February 3, 2025

Reference: 2 East Main Street
Southborough, Massachusetts
EDC Job No.: 3650

We are writing to address the Peer Review Comments as provided by Fuss & O'Neil dated January 9, 2025. The following addresses each point raised in their review letter with EDC's response in red.

DRAWING TITLE: CONSTRUCTION NOTES & DETAILS

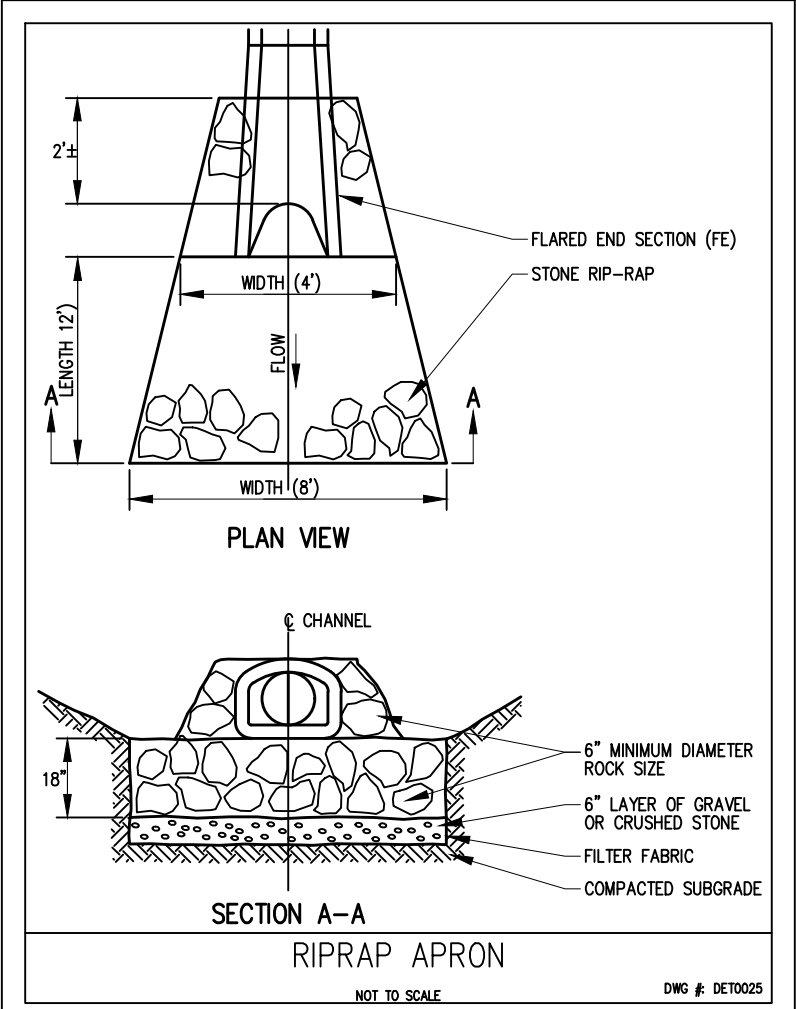
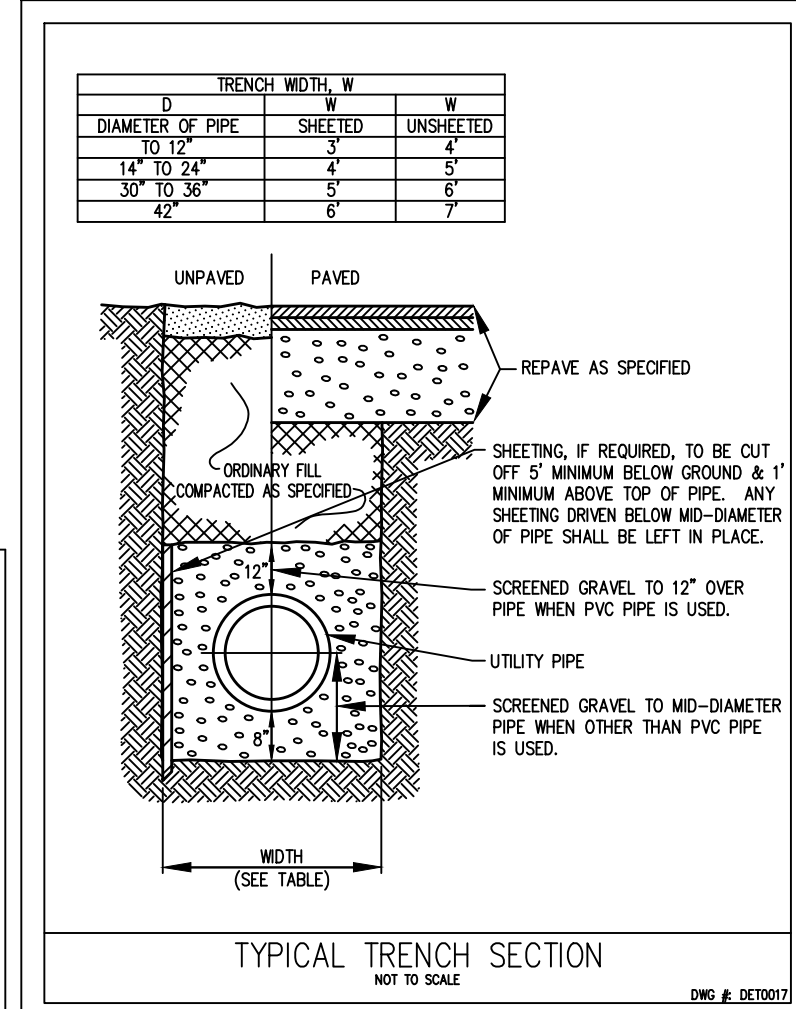
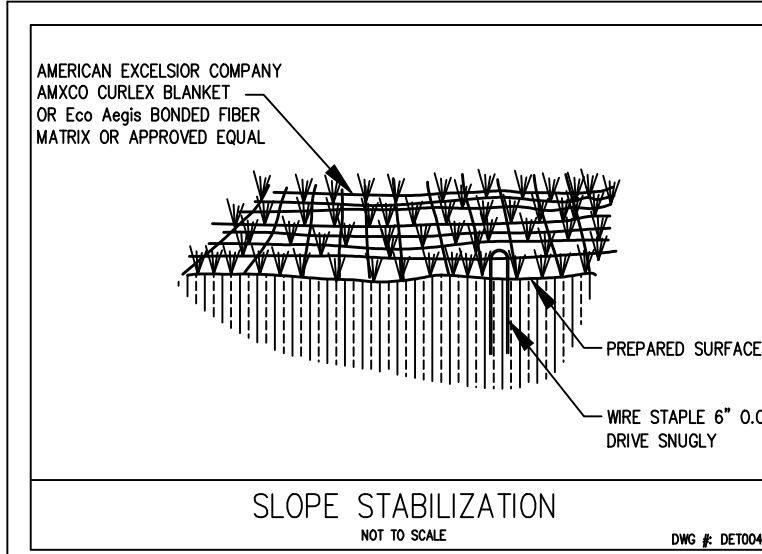
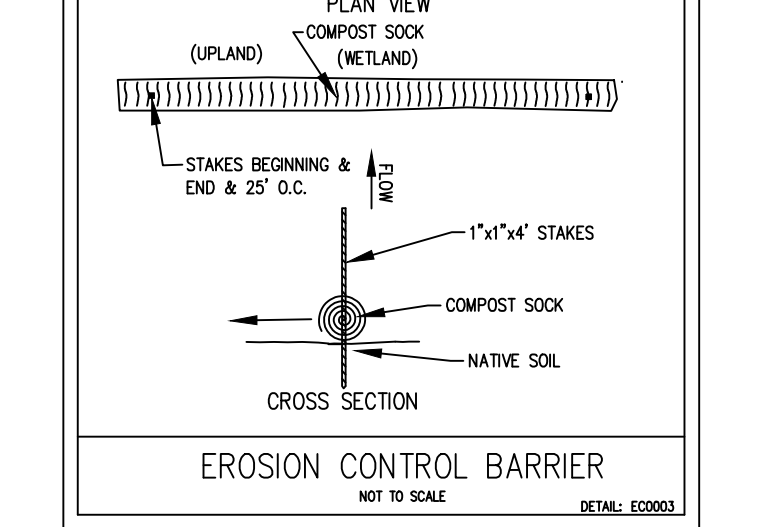
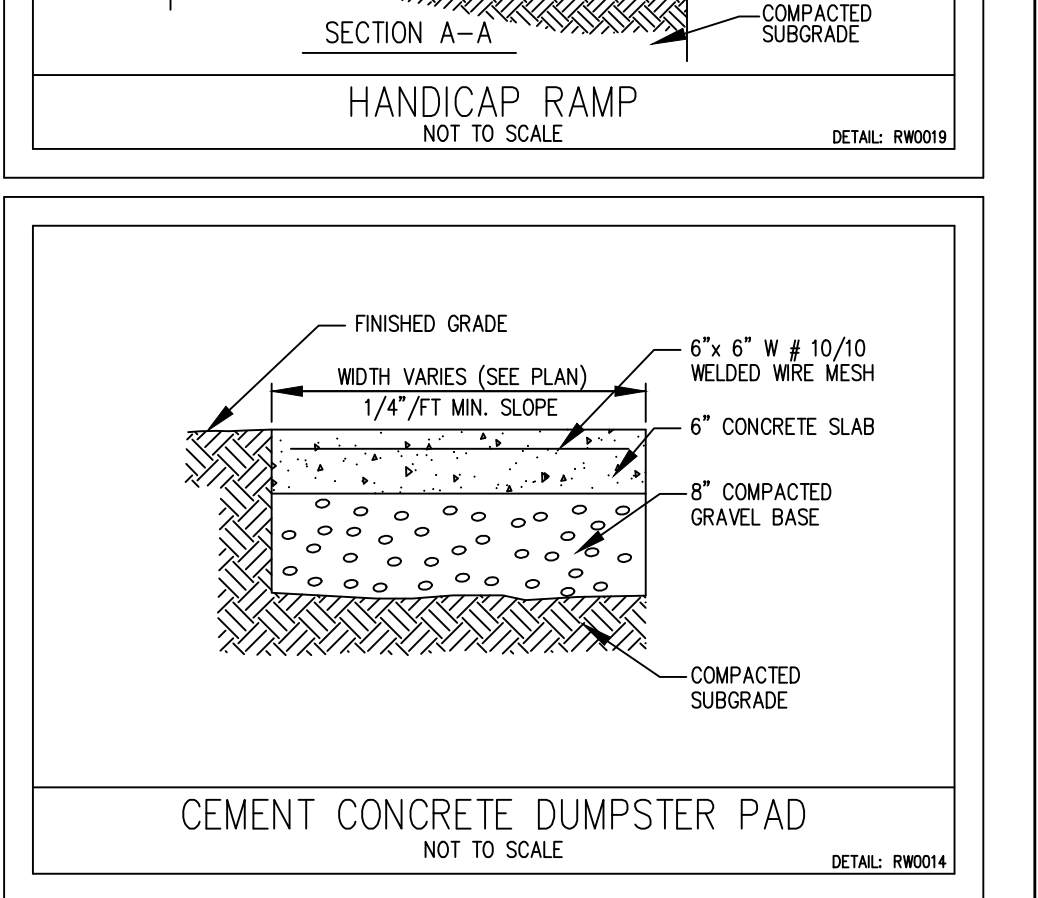
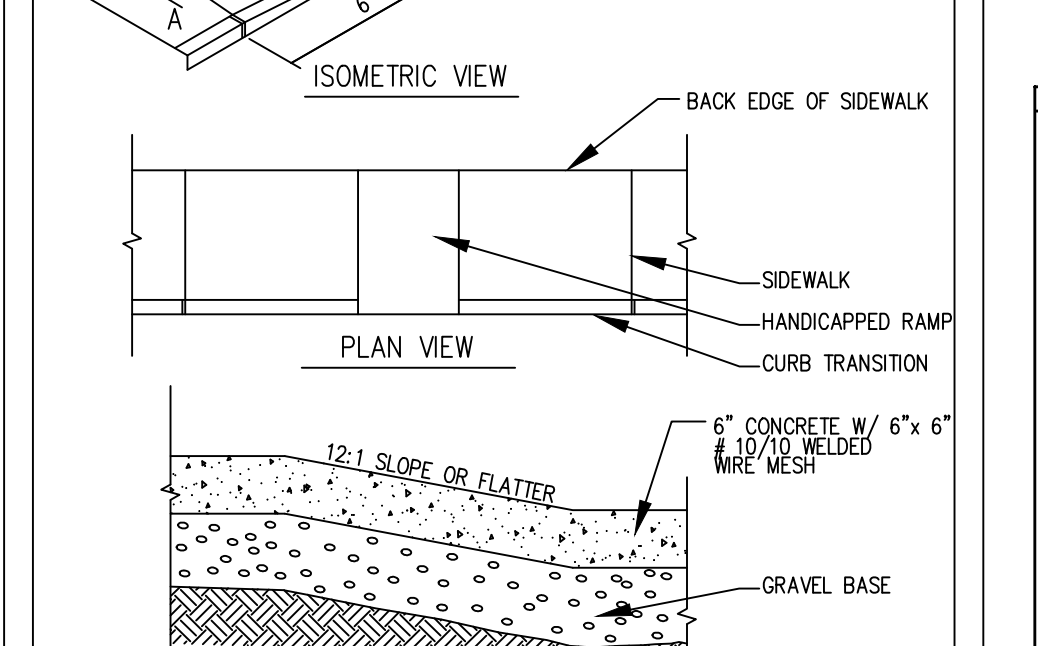
16. Per Section 174-13.5 I (1)(h) of the Zoning, Areas to be planted shall be loamed with not less than six inches compacted depth of good quality loam and seeded with turf grass seed or other appropriate ground cover in accordance with good planting practice. In review of the Proposed Site Plans, note 23 on sheet 4 calls for a minimum of 4" of loam. Please revise to ensure a minimum of six inches of loam.

17. Per Section 174-13.5 I (1)(m) of the Zoning, dust control shall be used during grading operations if the grading is to occur within 500 feet of the property line of an occupied residence or place of business. Dust control methods may consist of grading fine soils on calm days only or dampening the ground with water. Please revise both the Pollution Prevention and Operation & Maintenance Plan and Proposed Site Plans to include measures for dust control over the course of construction.

The note has been amended.

The SWPPP & O&M and Construction Note 8 on sheet 4 added to address dust control have been amended accordingly.
